CONVAIR
A Division of General Dynamics Corporation
San Diego, California

COMMERCIAL CHANGE PROPOSAL

SPEC NO: ZD-22-002

MODEL: (880) 22-1

CONVAIR 880 52" SEAT - TWA

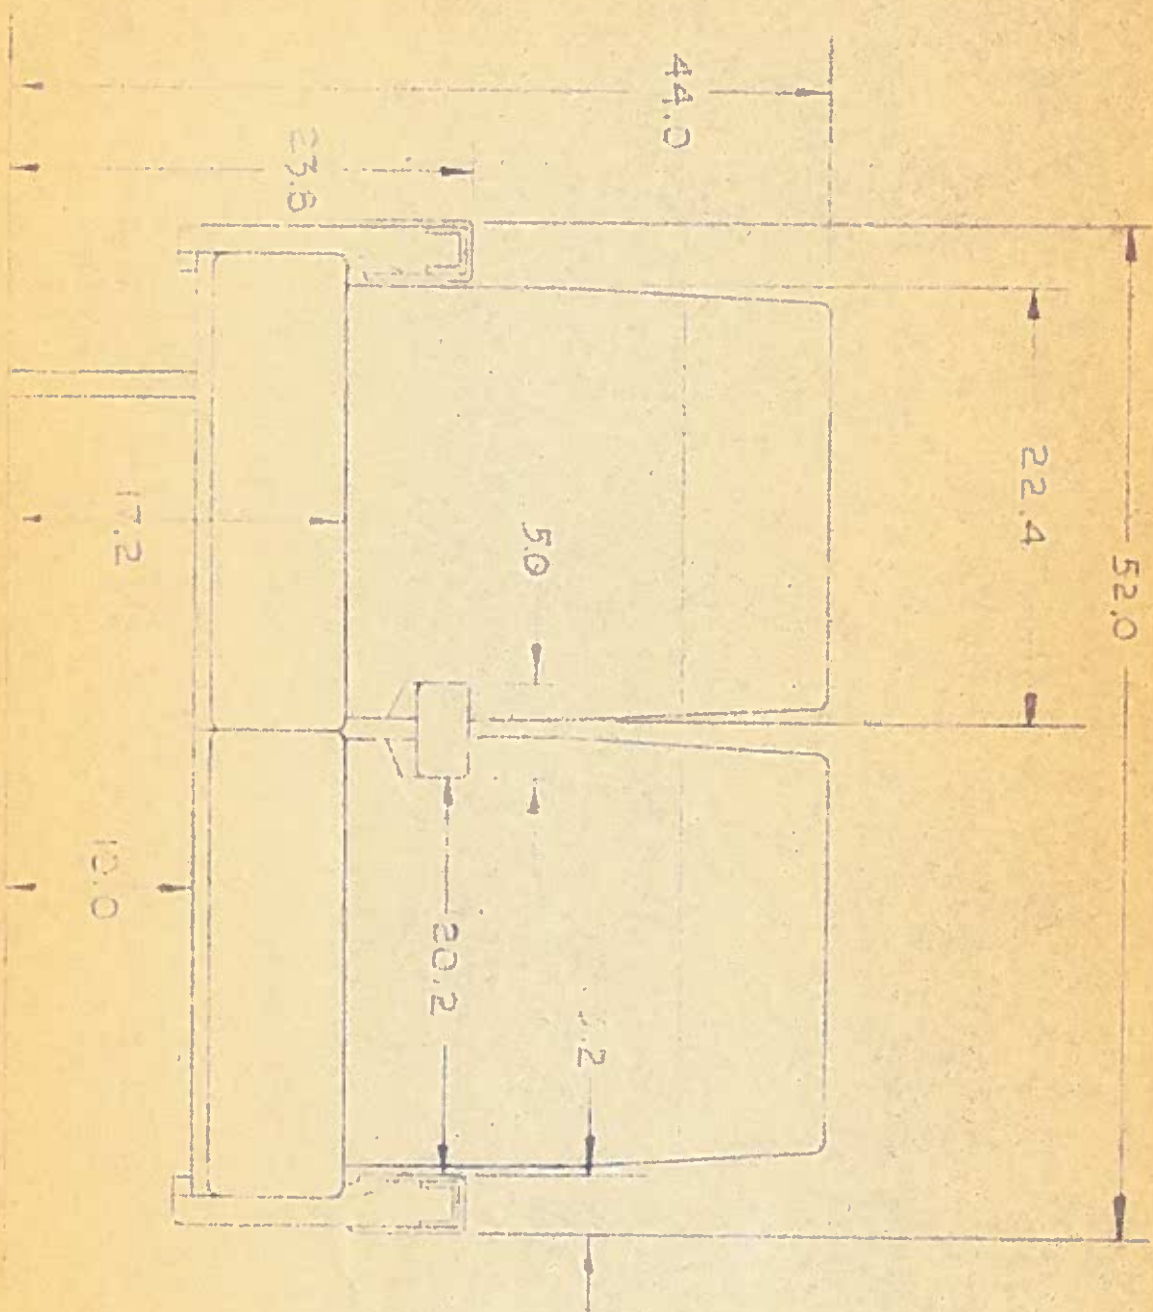
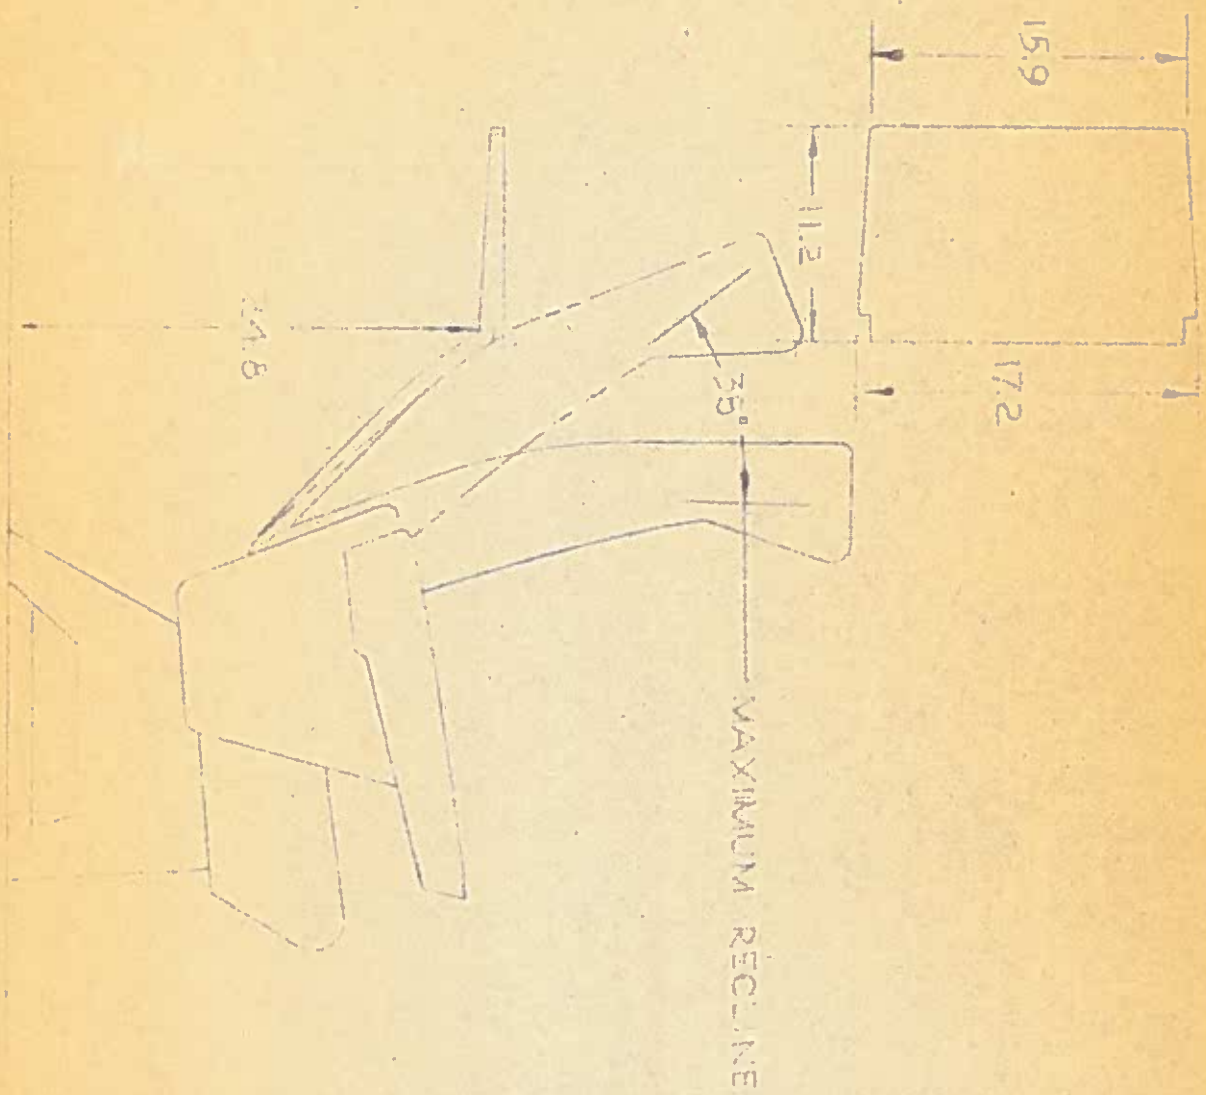
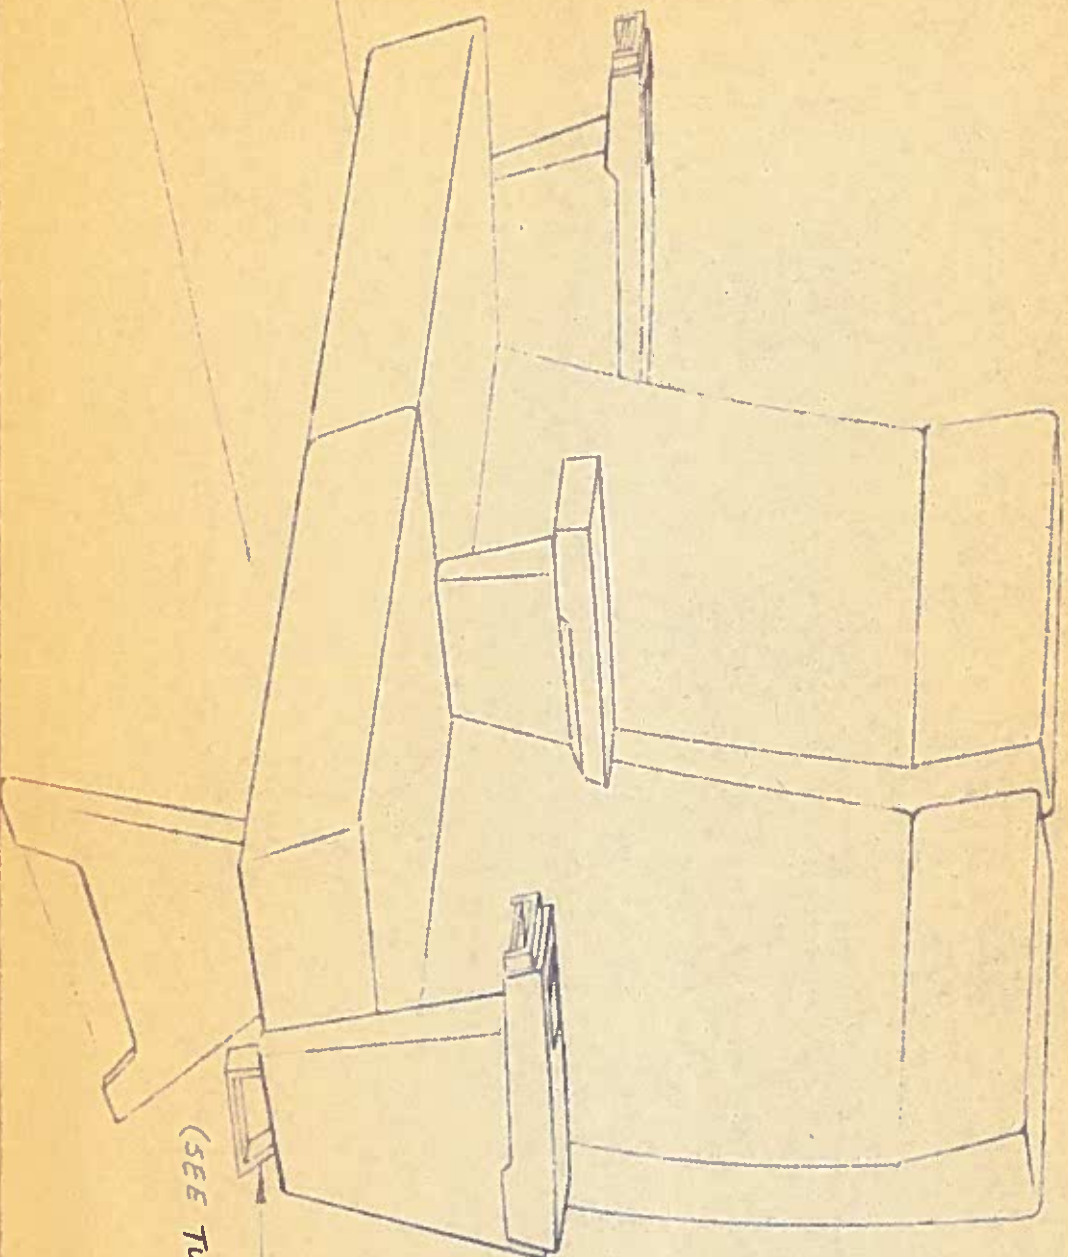
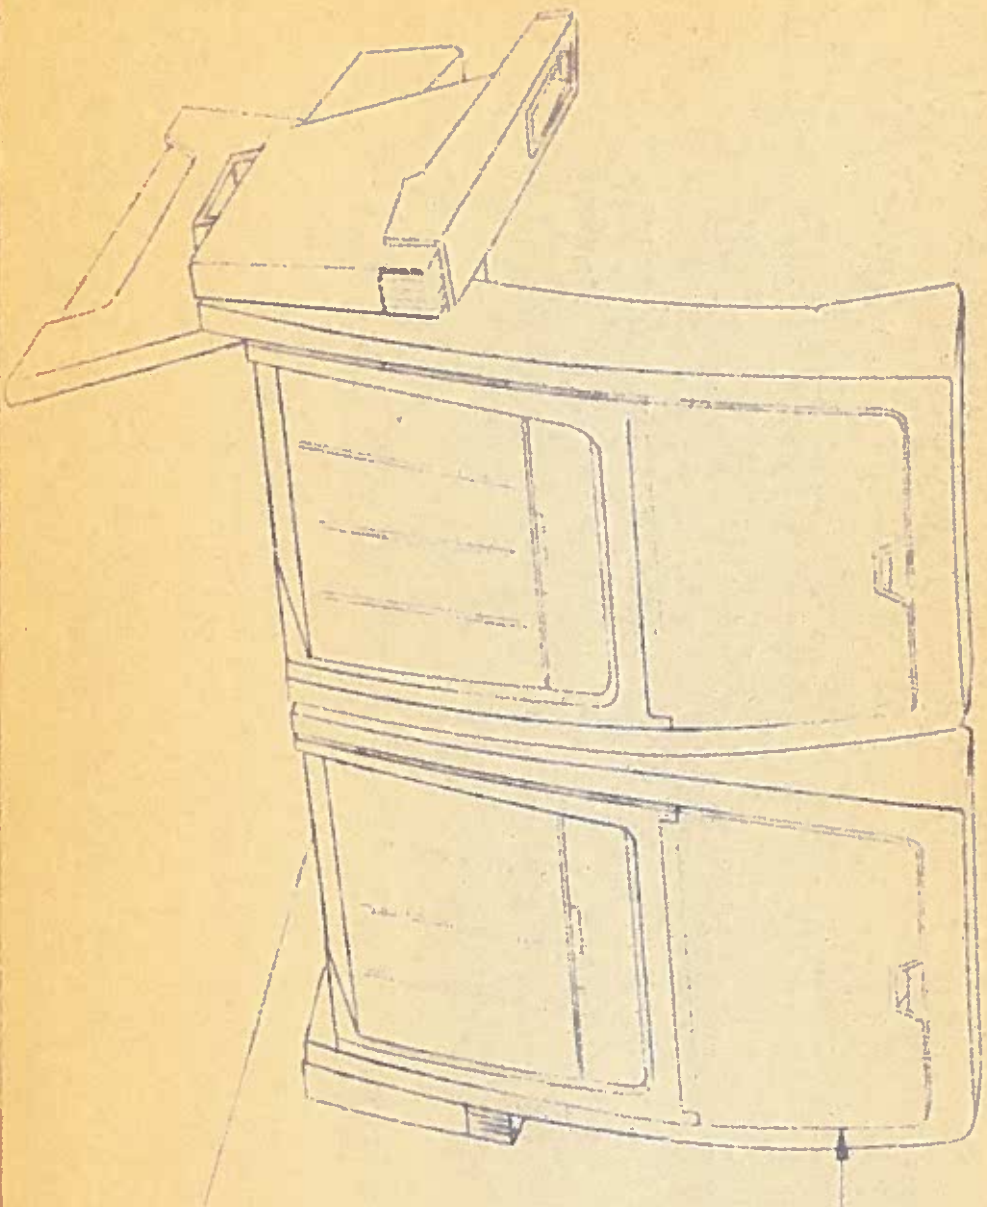
Page 2B, Figure 1-2 STANDARD SEATING ARRANGEMENT:

Revise Figure to show the following seat width and spacing:

Revise Standard Section of "Mixed Seating Arrangement" of figure in same manner as Figure 1-2.

FIGURE 3.19-4

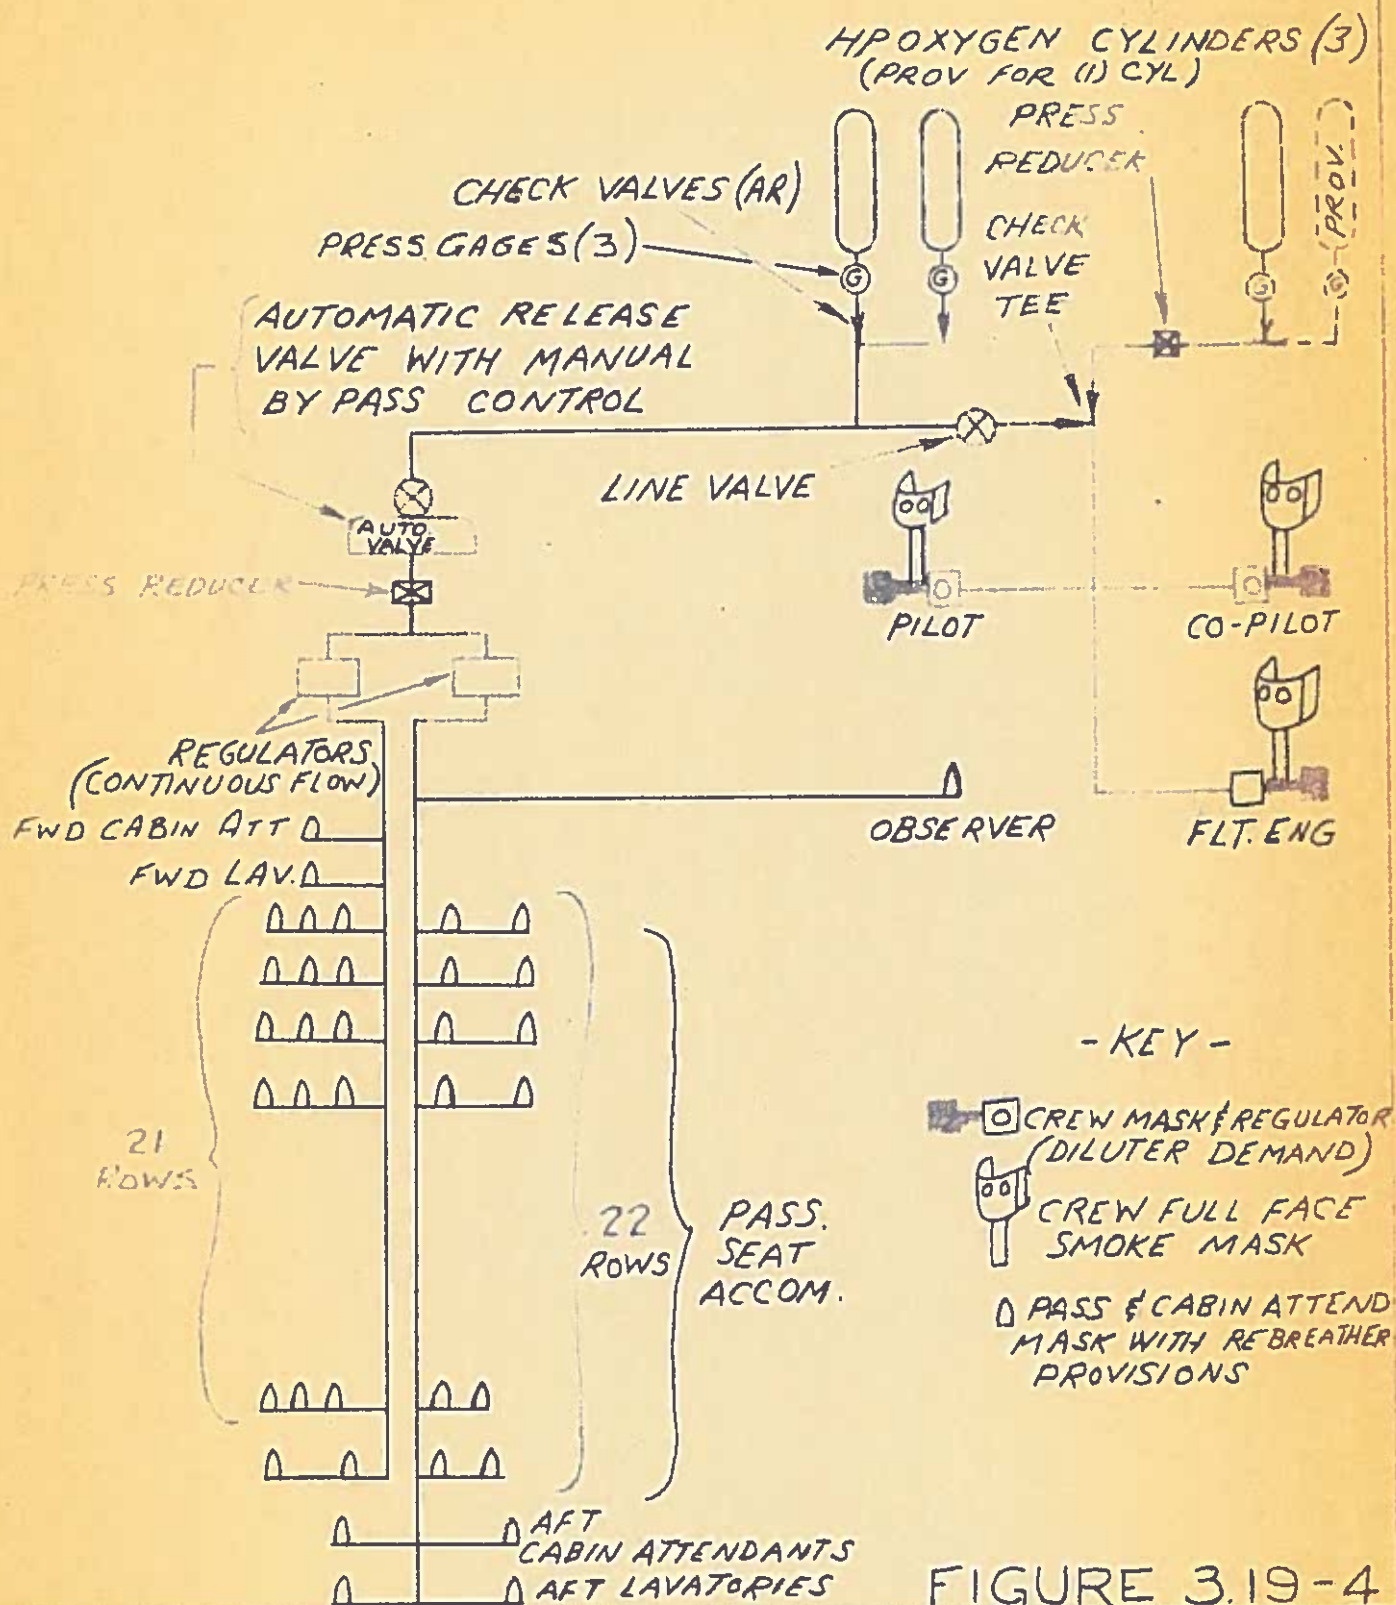
Figure 3.19-~~4~~ - Revise to show additional oxygen outlets.

Enclosure: (A) Figure 3.19-4 HIGH PRESSURE OXYGEN GAS SYSTEM (Revised)

FIGURE 3.19-2
(REV. 2-17-58)

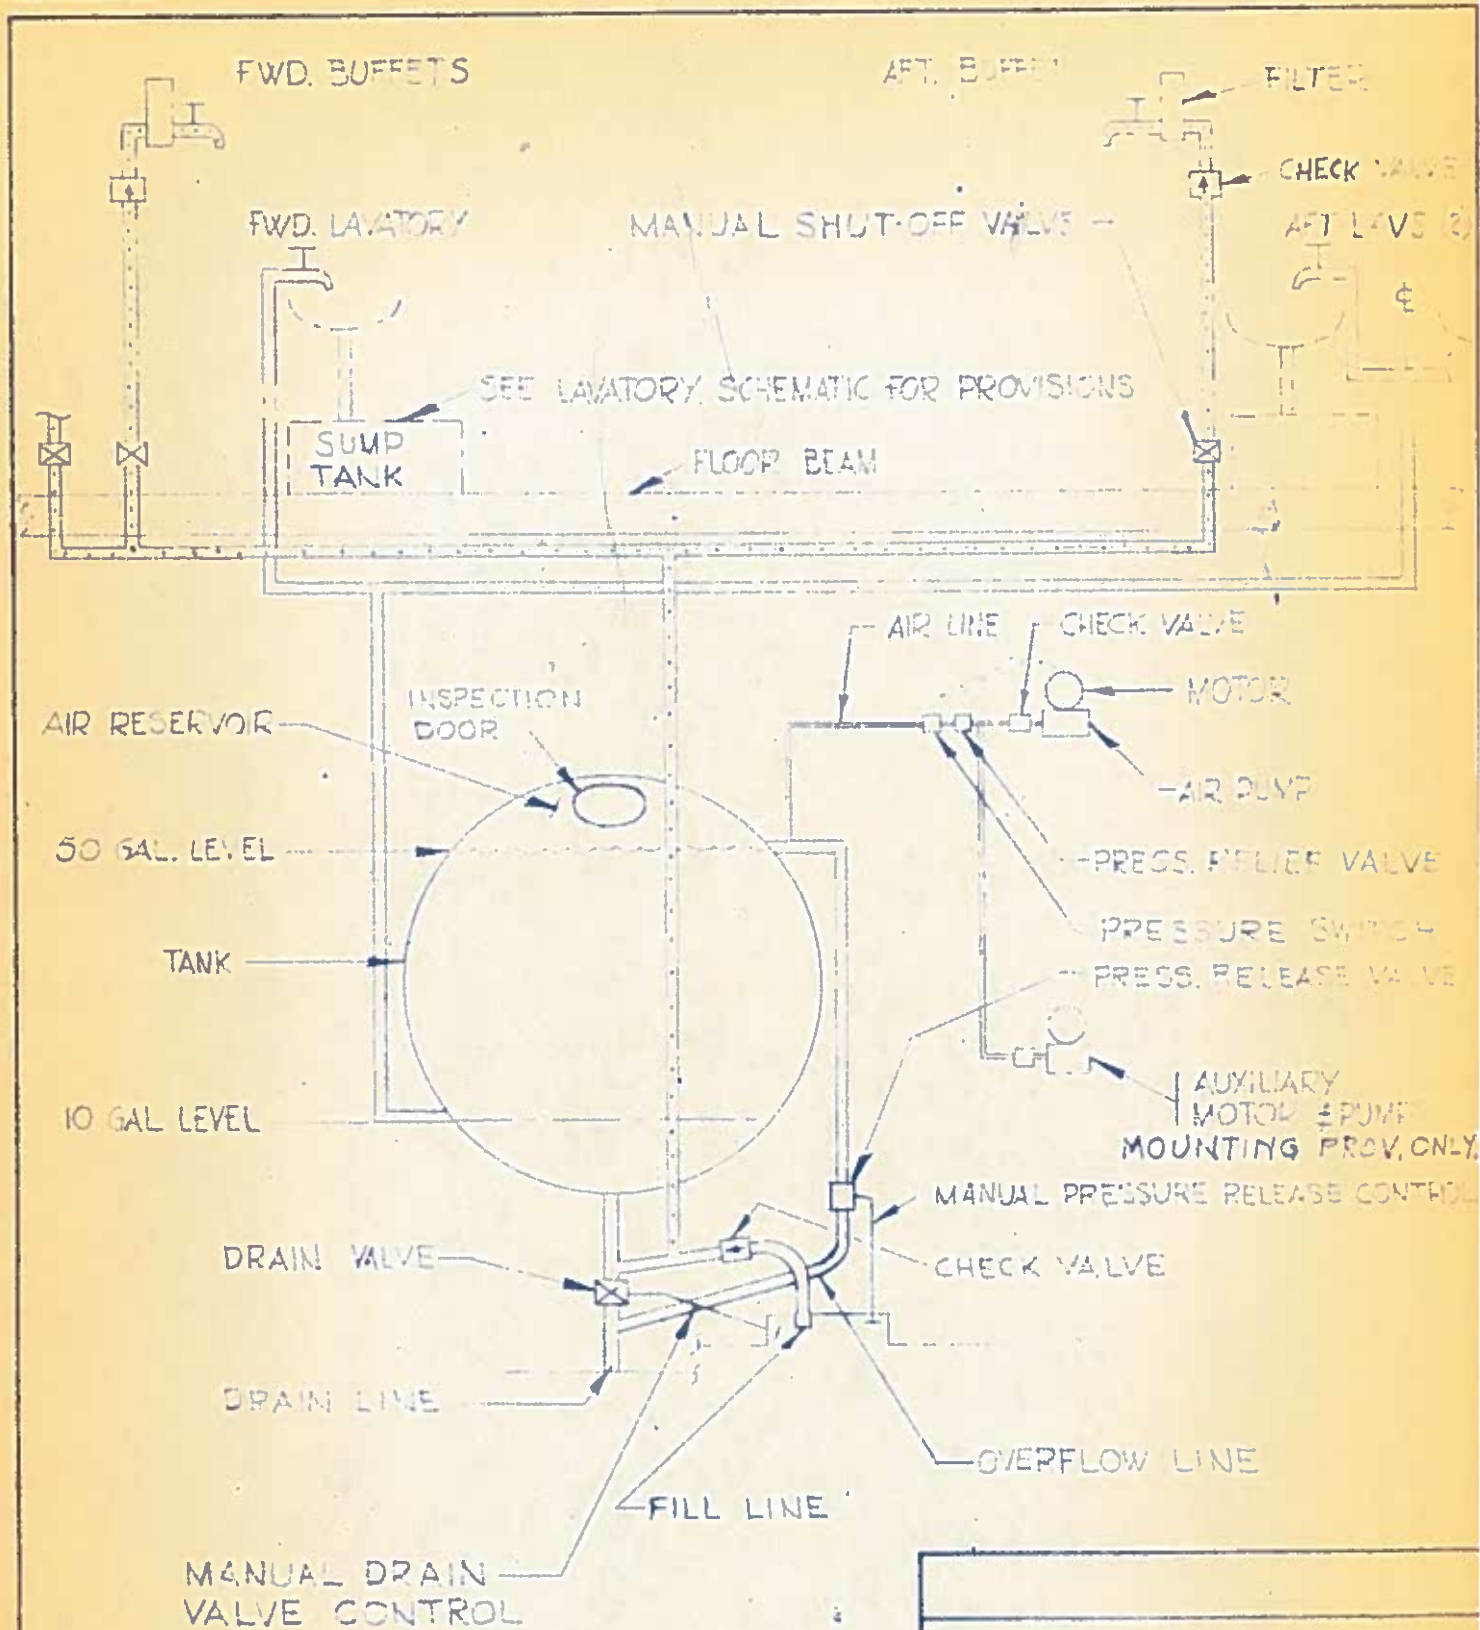
Figure 3.19-2 WATER SYSTEM SCHEMATIC:

Enclosure (A): One (1) copy of Figure 3.19-2 WATER SYSTEM SCHEMATIC
(revised 2-17-58)
